30-025-04930

From: Rabadue, Stephanie <Stephanie_Rabadue@xtoenergy.com>
Sent: Tuesday, March 25, 2014 9:09 AM
To: Brown, Maxey G, EMNRD
Subject: RE: Arrowhead Grayburg Unit # 126

WELL NAME: AGU 126
 LOCATION: 1980' FNL & 660' FWL, SEC 36 T21S R36E
 FORMATION: GRBG
 SPUD DATE: 06/24/40
 IP:

Proposed P&A WBD

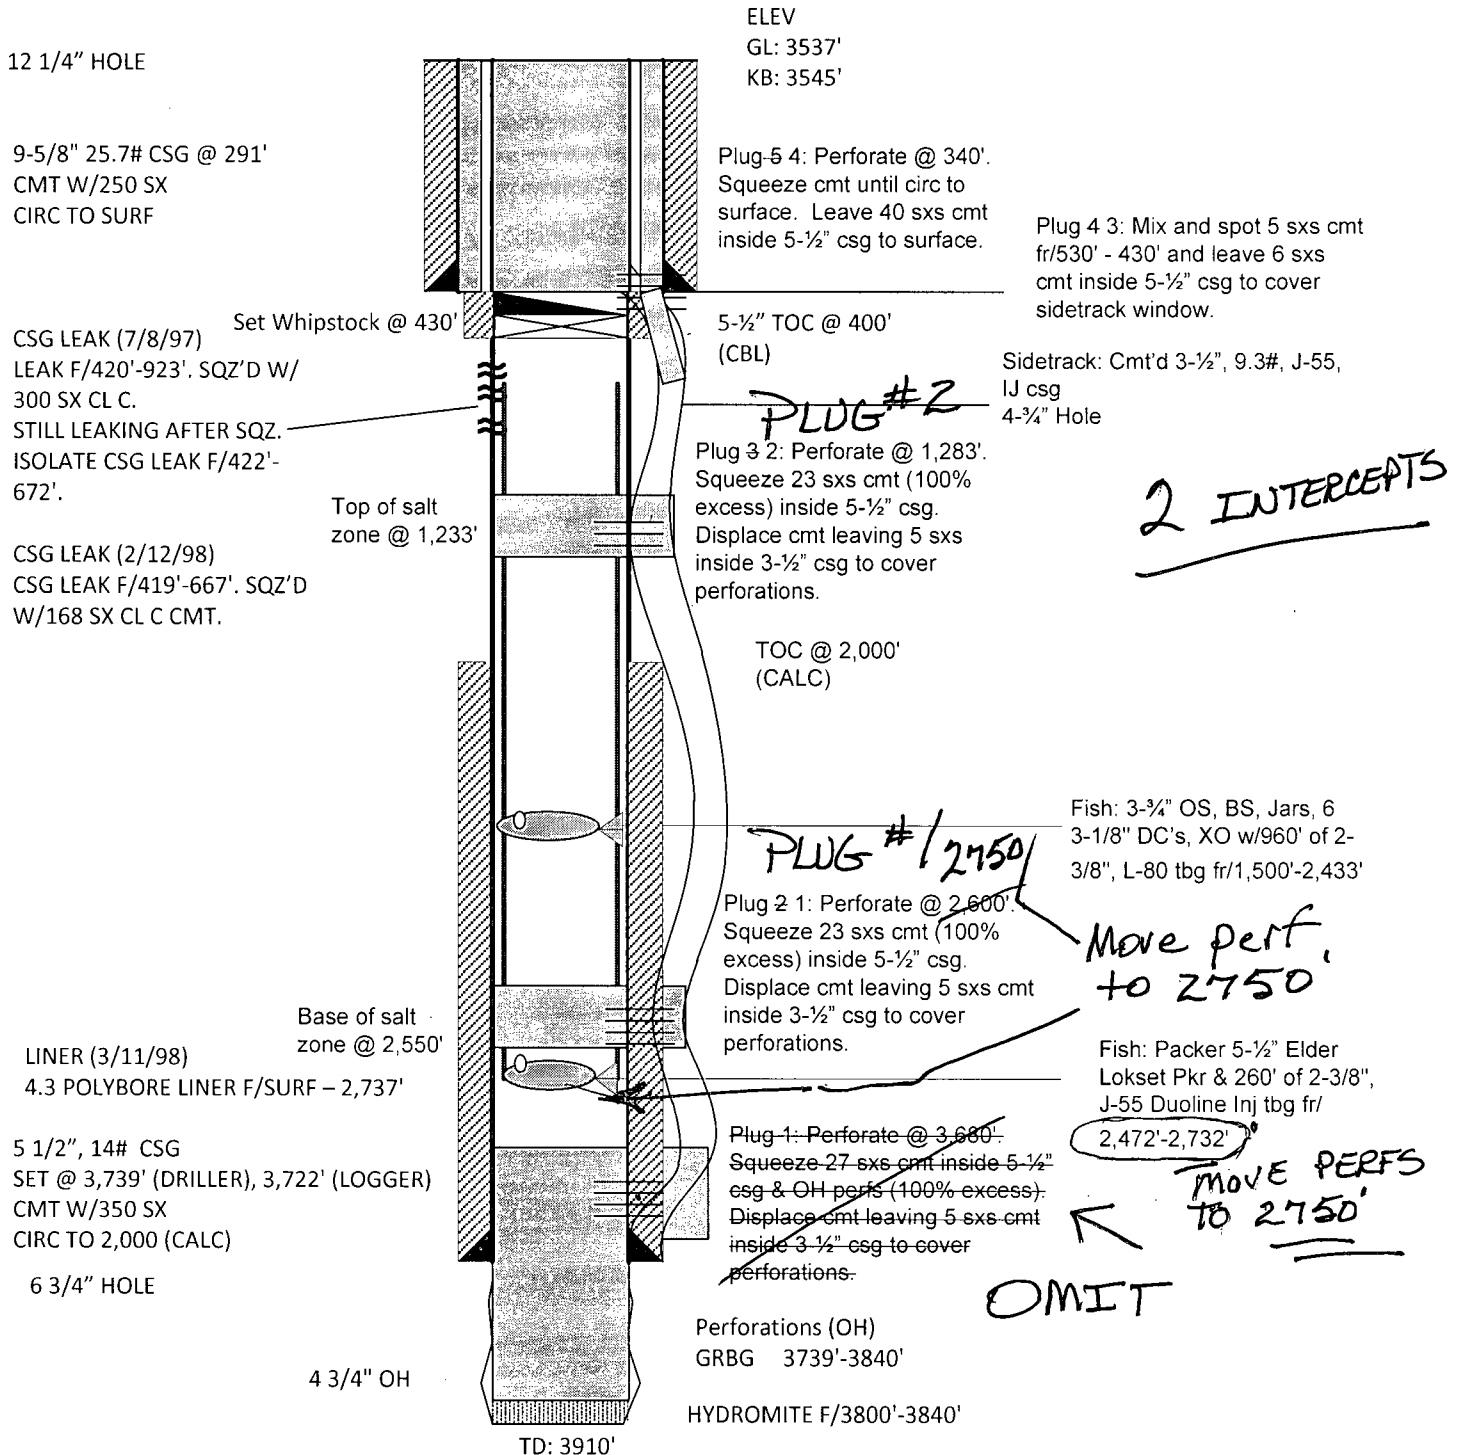
We're currently approved to sidetrack PxA the AGU #126 (API: 025-04930) with three intercept points. My drilling operations engineer is concerned as the more intercept points in a sidetrack PxA, the more risky the venture. He is wondering if the following would be acceptable and not threaten the injection integrity of our unit:

1. Eliminating the 3rd intercept point at +/-3680'. This would mean that we would not have a plug throughout our producing interval or fill the wellbore with cement.

However, the rest of the program would stay the same with two intercept points at the top and base of the salt zones (+/- 2600' & 1283' respectively).

actual sketch, at this time, is where we originally intended to set our plugs with the intercept well. I've done strike-through with the original plugs that we're currently approved for at this time but have left them on the diagram as a demonstration of both what we'd like to change it to and what we're approved for currently.

Would you please attach a current wellbore schematic indicating where the fish are in the casing. Also do you know if an attempt was made to pump down the wellbore with any fluids after the fish where lost in the hole.

Stephanie,
Ok, if we use 2 intercept points, drop lower intercept point from 2600' to 2750'. This will put cement between the open perforations and the lower fish. Increase cement volume to a minimum of 25 sxs or greater, depending on pump in rate. This gives a plug between producing zone and base of salt. Any questions give me a call.
Maxey

CHANGES TO ORIGINAL C-103
 ALL CHANGES WILL BE INCLUDED
 ON C-103 SUBSEQUENT
 MMS 3/25/2014
